NEBRASKA CAPITOL ENVIRONS COMMISSION STAFF REPORT

APPLICATION NUMBER	Urban Design Record #24032
APPLICATION TYPE	Certificate of Appropriateness
ADDRESS/LOCATION	401 S 14th Street and 1335 L Street
HEARING DATE	January 26, 2024
ADDITIONAL MEETINGS	December 22, 2023 and January 26, 2024
APPLICANT	Lynn Rex, League of Nebraska Municipalities, <u>lynnr@lonm.org</u>
STAFF CONTACT	Collin Christopher, 402-441-6370, cchristopher@lincoln.ne.gov

League of Nebraska Municipalities Office

Capitol Environs – Design Review

SITE PLAN: HARDSCAPE

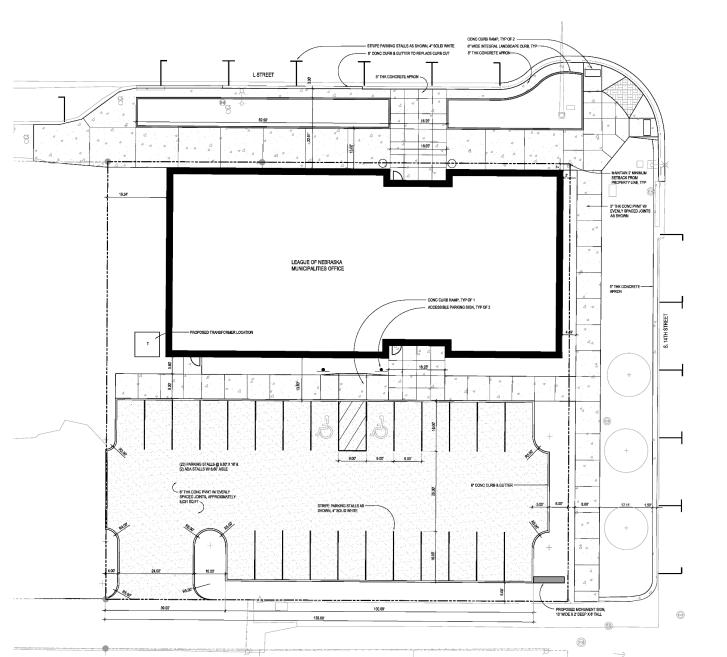
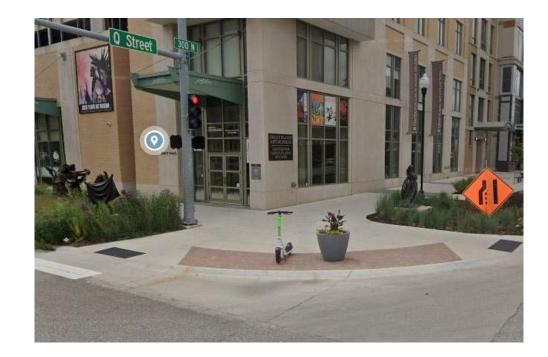
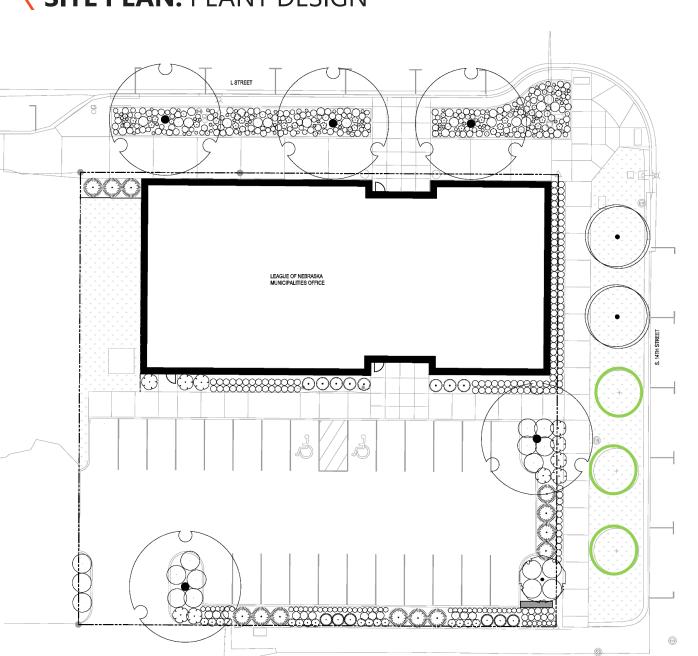
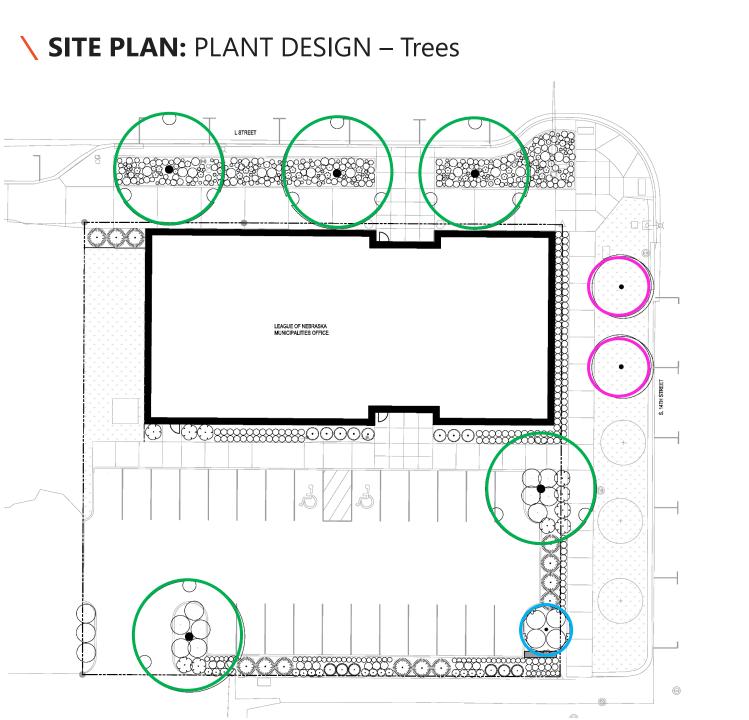
- Bump out along L Street to support safe pedestrian crossing, preserve 14th Street inlet
- Band of pavers at intersection
- Longer contiguous planter along L Street
 - 3' wide concrete apron to support parking
